Vibration Symptom - Vibrations From Footwell and Steering Wheel Area: Replacing grommets and spacer sleeves for pressure pipes (SY 40/19)

Vehicle Types: **Cayenne (9YA)/Cayenne E-Hybrid (9YA)**

Subject: **Securing pressure pipes to lock carrier**

Front release element

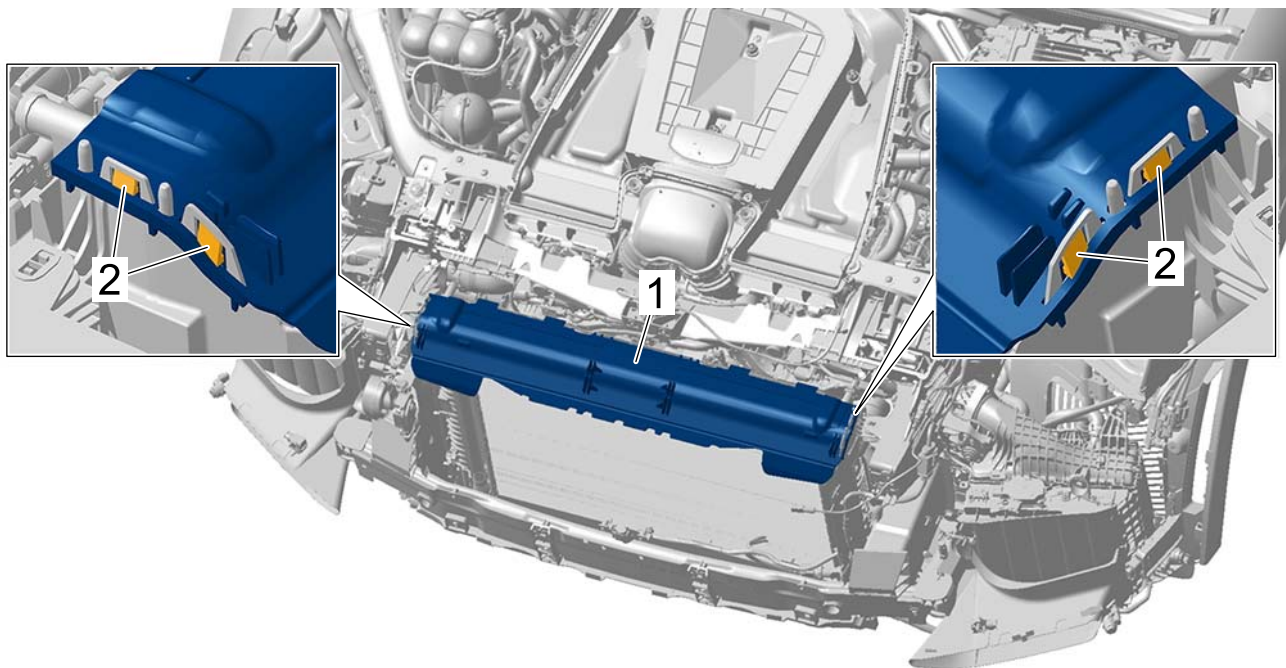
- Work Procedure: 1 Remove front release element (⇒ *Front release element -1-*).

- 1.1 Unscrew screws (⇒ *Front release element -2-*).
- 1.2 Pull front release element (⇒ *Front release element -1-*) up off the guide on the lock carrier (⇒ *Front release element -arrow-*) and set it aside.

Radiator cover

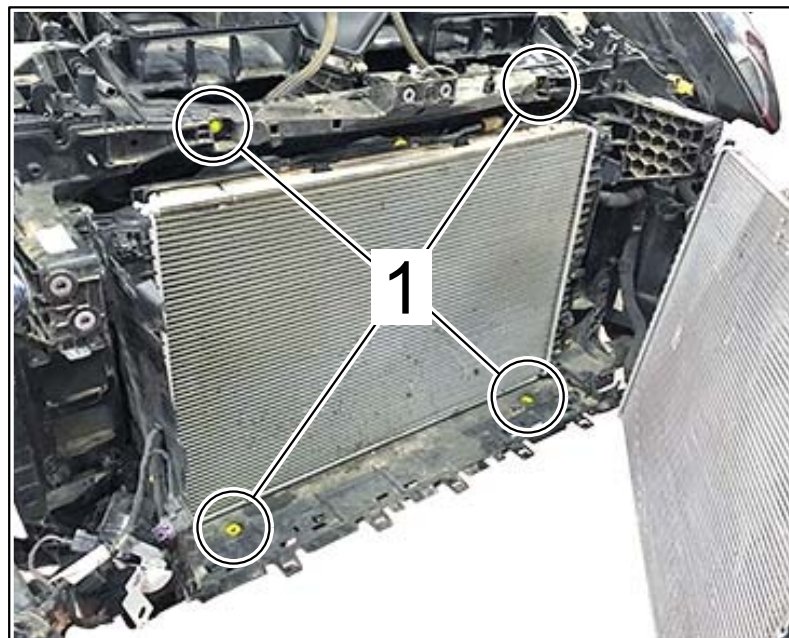
- 2 Remove radiator cover (⇒ *Radiator cover -1-*).
- 2.1 Press in clips (⇒ *Radiator cover -2-*) and pull radiator cover (⇒ *Radiator cover -1-*) up and off.
